FIRE SAFETY INSPECTION REPORT

Comfit Composite Knit Ltd. (Extensions 2)

Date: 8 May 2023

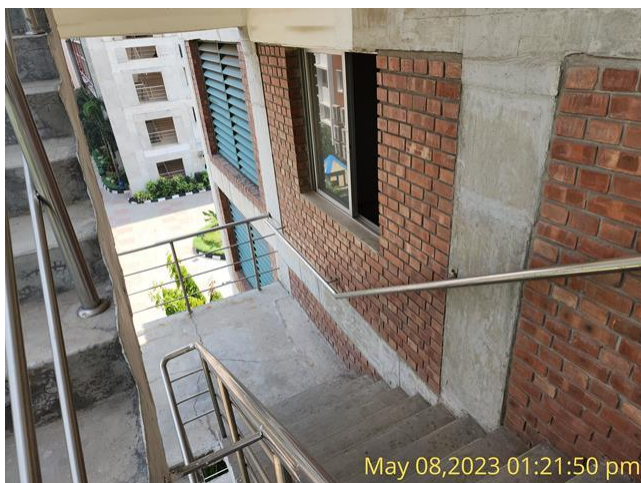
F-5	Egress	Exit discharge path not leveled surface (New Utility Building).	Level the exit discharge path to ensure smooth and safe evacuation and ensure that the path is slip resistant.	Within 1 month
-----	--------	---	--	----------------

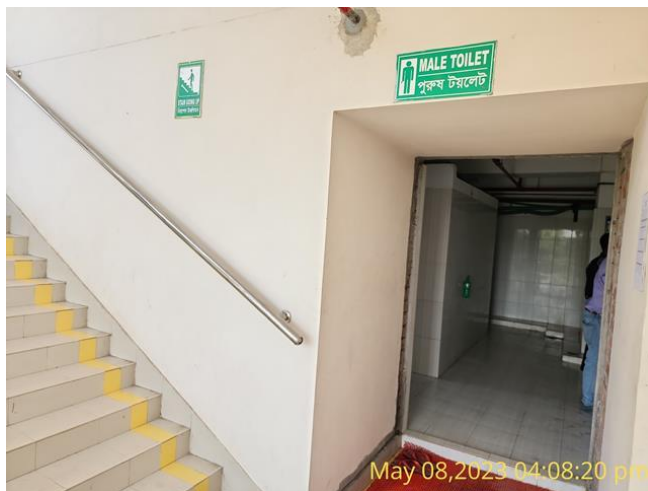
F-7	Fire Rated Construction	Areas used for combustible storage open to the factory are not properly defined and/or not within limits. (Banana Leaf –1 st floor Eco ville – Mezzanine)	Provide defined storage areas and limit the storage arrangement as follows: Maximum height of 2.45m (8 ft) and maximum area of 23 m² (250 ft²). If sprinkler protected: maximum height of 3.66m (12 ft) and maximum area of 93m² (1000 ft²). Separate the areas of unenclosed combustible storage by a minimum clear distance of 3 m (10 ft). Areas shall limit within 10% of entire floor area.	Within 2 months
-----	-------------------------	--	---	-----------------

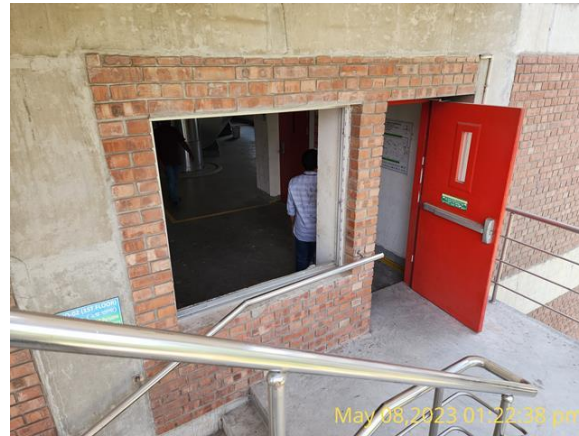
F-9	Fire Rated Construction	Exit doors are provided with 2 hr fire rated doors however fire door accessories are not working as required. Also several door has no credible listing mark. (All buildings)	Separate the exit stairs from work areas and other building spaces on all floor levels by minimum 2- hr fire-rated construction. Provide minimum 1.5- hr fire rated doors and seal all unprotected openings and penetrations to maintain the fire separation (10" wall). Ensure that all fire doors are self-closing and positive latching, and are provided with fire exit (panic) hardware where serving production floors or assembly occupancies. If fire doors are required to be held open for functional reasons, provide automatic-closing devices tied to the fire alarm system. Once fire doors are installed, every door in a stair enclosure serving more than 5 stories shall be provided with re-entry unless it meets RSC 6.8.3.1.	Within 1 month
